OG97-044-161  
January 30, 1997

Subject: ***BWR Owners' Group Response to NRC Comments and Questions Regarding NEDO-32686 Revision 0, "Utility Resolution Guidance for ECCS Suction Strainer Blockage"***

### **BWR Owners' Group Response to NRC Comments and Questions Regarding NEDO-32686 Revision 0, "Utility Resolution Guidance for ECCS Suction Strainer Blockage"**

Figure 2

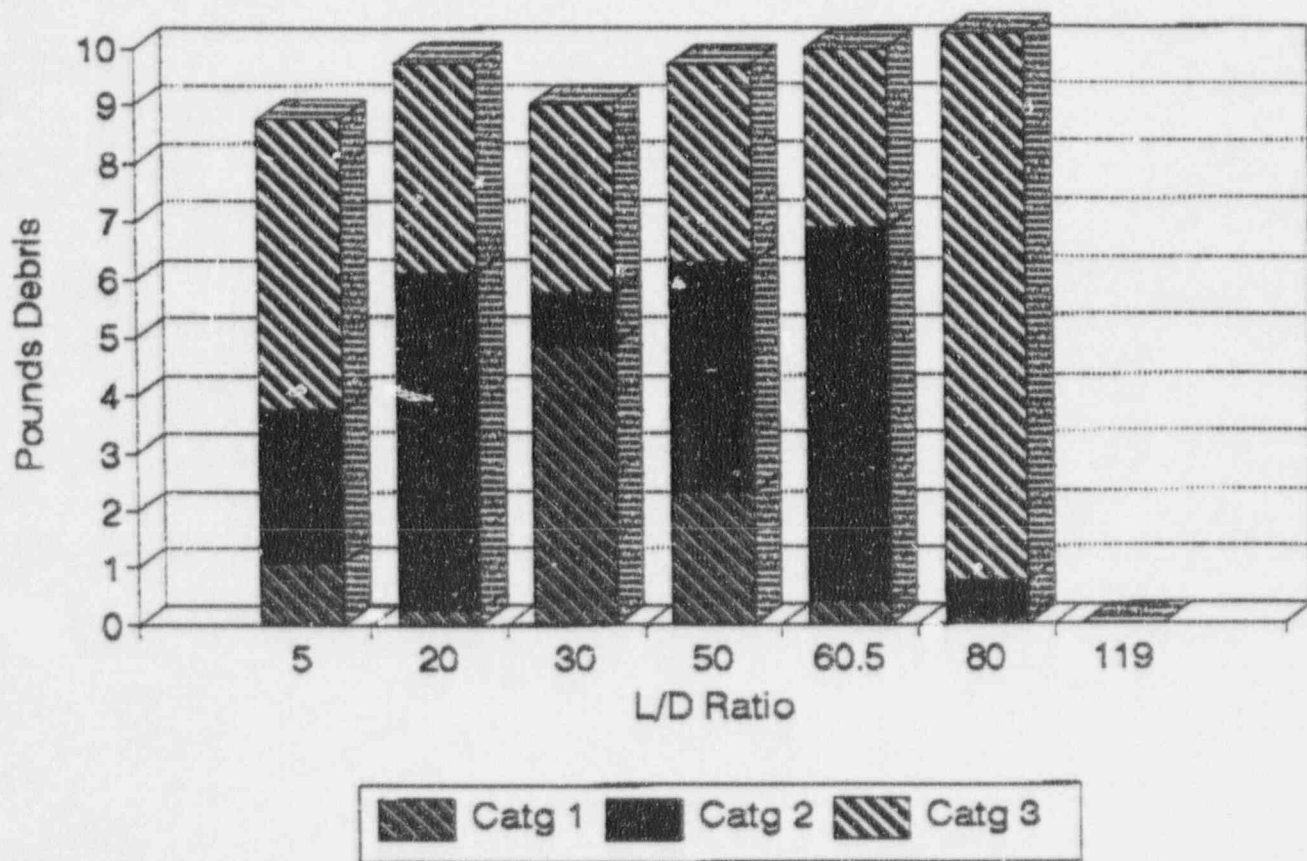
This comment expresses an NRC staff question on how the results shown in Figure 1 in Appendix E of URG Reference 5 are adjusted for a ZOI that is smaller than 100D.

1. The staff is interested in how transportability (i.e., transport fractions) of materials other than NUKON and RMI was determined. The tests at CDI seem to focus on NUKON and RMI. The staff is interested in knowing if enough data was collected during the BWROG test program to assess the transportability of materials other than NUKON and RMI.
2. How should/are results shown in Figure F1 in Volume II, Tab 2 on Page E-2 adjusted for ZOI that are smaller than 100D. The staff is concerned that transportable debris will be under predicted if these results are not adjusted for smaller ZOI.

Questions regarding the application of the curve relating percent large fibrous debris as a function of distance from the pipe break (URG Reference 5 in Technical Support Documentation Volume 2, Tab 2, Page E-2) were resolved during the meeting with the NRC on December 17, 1996. The percent large fibrous debris (y-axis parameter) is determined using this graphical correlation after the equivalent spherical diameter of the zone of influence (x-axis parameter) is calculated.

There is a substantial amount of data for Nukon from the BWROG sponsored air jet test program which demonstrates how the generation of material with low transport efficiency varies as a function of insulation target distance from the test nozzle. The linearized model provides a reasonable fit to the data and all other insulation materials should follow a similar trend. Furthermore, for all materials there is a distance from the break for which the material is not destructed ( $\eta_B$  equals 100 percent) as was demonstrated by the Nukon data. This provides an additional data point to provide a best estimate of the linearized fit. It is our opinion that running additional tests for the other insulation materials will not significantly change the estimated

values for the average fraction of blanket material with low transport efficiency that are presented in the Technical Support Documentation, Volume 2, Tab 2, Appendix E, page E-3.
